RR-C-430A
AMENDMENT-2
August 30, 1968
SUPERSEDING
Int. Amendment-1
June 26, 1967

FEDERAL SPECIFICATION

CLIMBER SET, TREE AND POLE: STEEL, INTERCHANGEABLE

GAFF, W/NYLON-NEOPRENE COATED STRAPS

FIGURE 4. CALF PAD ASSEMBLY, TYPICAL

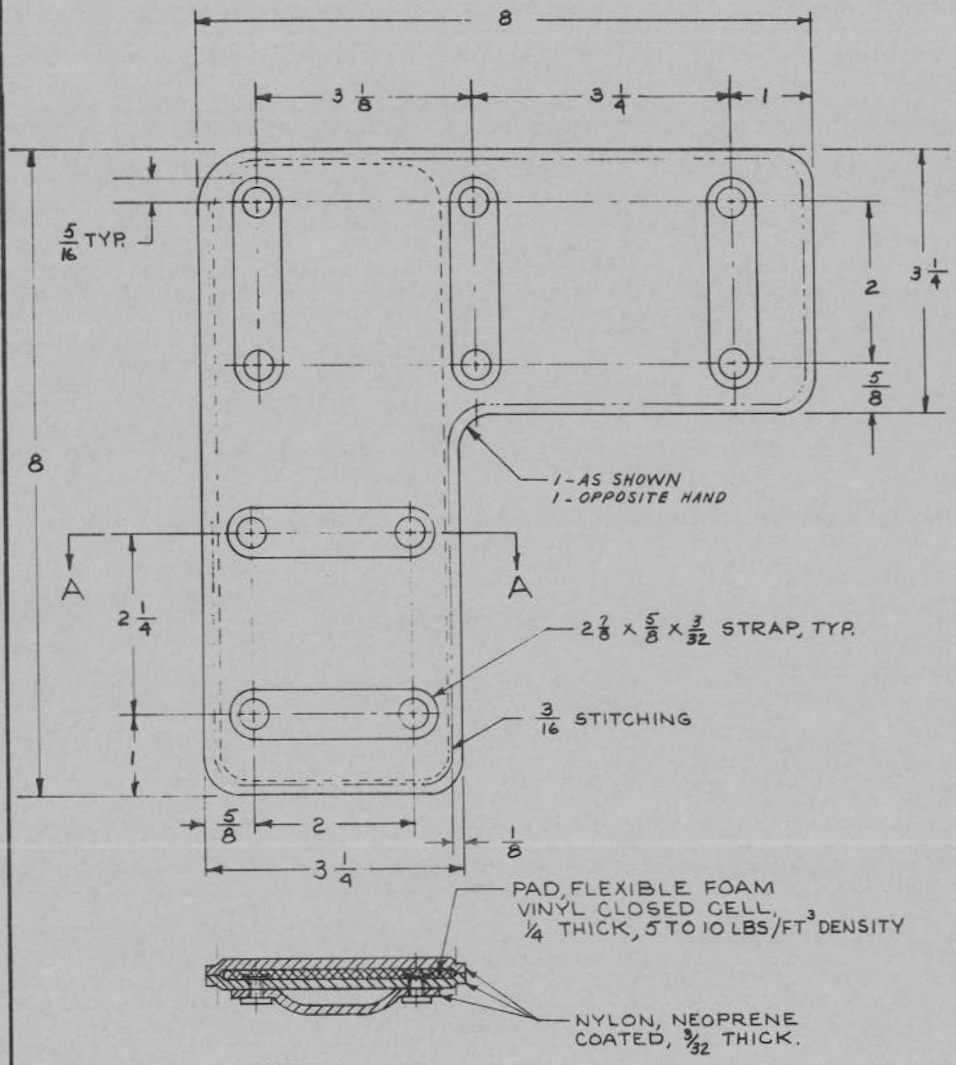
Figure 4: Delete and substitute revised figure 4.
